May 15, 2013  
NRC3-13-0018

Subject: DTE Electric Company Response to NRC Request for Additional Information Letter No. 85

**Response to RAI Letter No. 85**  
**(eRAI Tracking No. 7077)**

**RAI Question No. 03.07.02-11**

Figure 1: Geometry of Cylindrical Foundation Cross Section

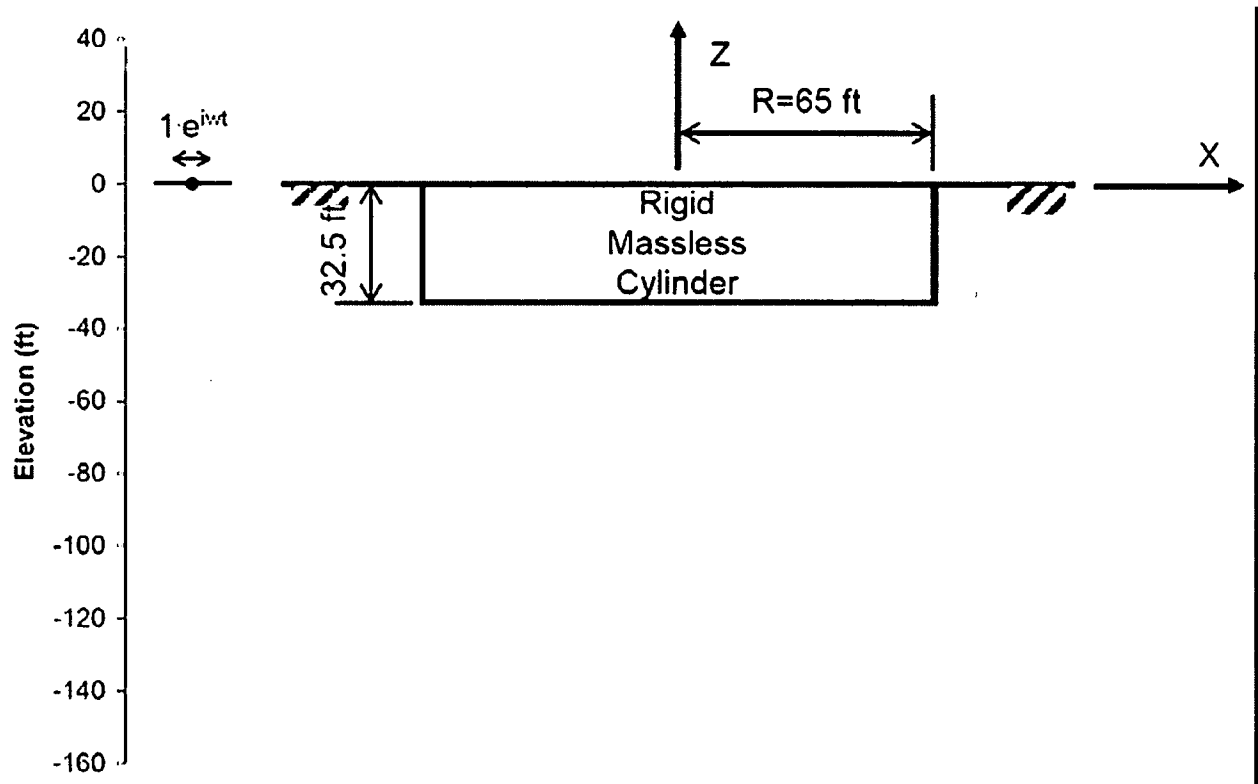
*During the audit the staff determined that the test problems did not include validation for transfer functions or impedance functions, for frequencies above approximately 20 Hz up to 50 Hz for the Fermi 3 site.*

*In accordance with 10 CFR Part 50, Appendix S, to ensure that the seismic SSI analyses performed using SASSI2010 in support of the Fermi 3 Combined License application are adequate for the full frequency of interest at the Fermi 3 site, the applicant is requested to supplement the SASSI2010 V&V with additional test problems that address the issue identified above. This RAI also supplements RAI 03.07.02-9.*

The geometry of the model is shown in Figure 1 and the isometric view of the finite element model of the rigid, massless structure is shown in Figure 2. Figure 2 also shows the excavated volume. The excavated soil and the rigid, massless structure are attached to independent internal node sets. On the perimeter of the excavation, the excavated soil and the rigid, massless structure are attached to the same nodes. As shown in Figure 2, only half of the foundation is modeled. Symmetry about the XZ plane is used to reduce the size of the problem. The foundation radius,  $R$ , is equal to 65 ft, and the embedment depth is 32.5 ft. This results in an embedment depth to foundation radius ratio of 0.5 (dimensionless parameter  $H$ ). The parameter  $H = 0.5$  is selected because Day's solution is provided for  $H = 0.5$ ,  $H = 1.0$ , and  $H = 2.0$ . For the Fermi 3 RB/FB, the  $H$  value is 0.6 (embedment depth of about 65.6 ft and equivalent radius of about 108.4 ft.), which is close to Day's reported value of  $H = 0.5$ .
